## DEVELOPMENT AMENDMENT DA 3905 (2020-128)

### **Development Application - Proposed Development Amendment**

*To increase the number of public allowed from 70 to 250.*

In discussion with the Shires Planning Department it was agreed to submit a Development Application (DA) to amend the existing DA 3905 (2020 -128) for the tourism project referenced as THE DAM located at Raintree Estate, Lot 305 Wentworth Road, Denmark WA. This amendment is to allow up to 250 people at the venue excluding staff.

## **13. SITE SPECIFIC ISSUES**

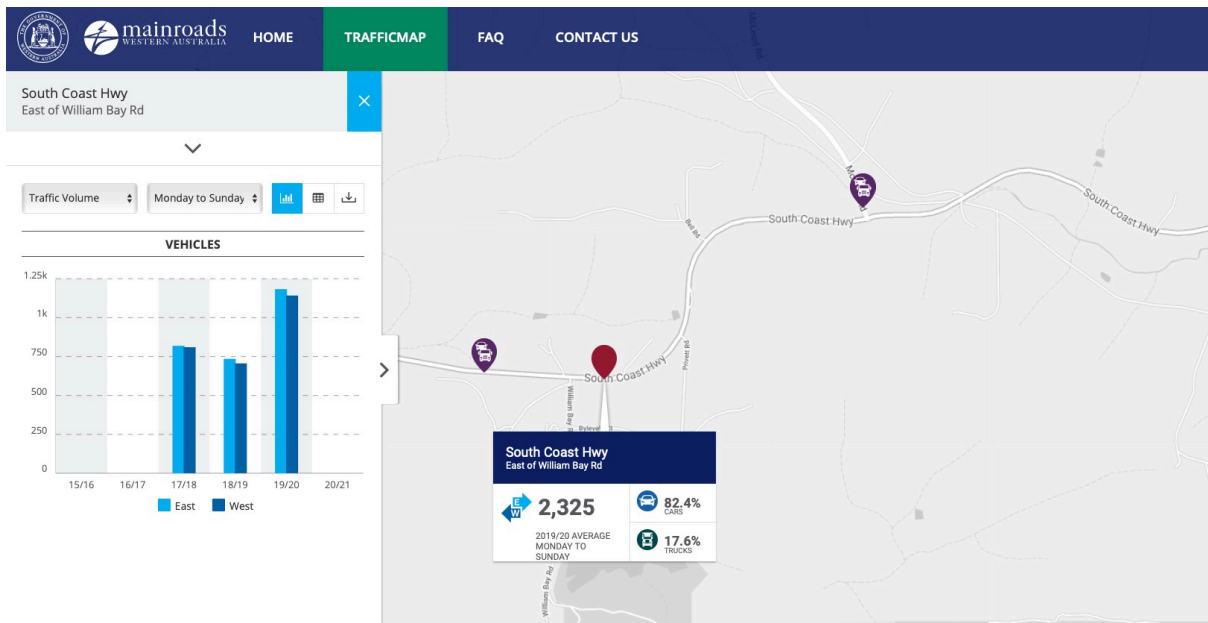
- 13.1. The internal access road has a gradient that obstructs forward visibility of traffic accessing the car park. It is understood that the gradient is to be adjusted to remove this issue.
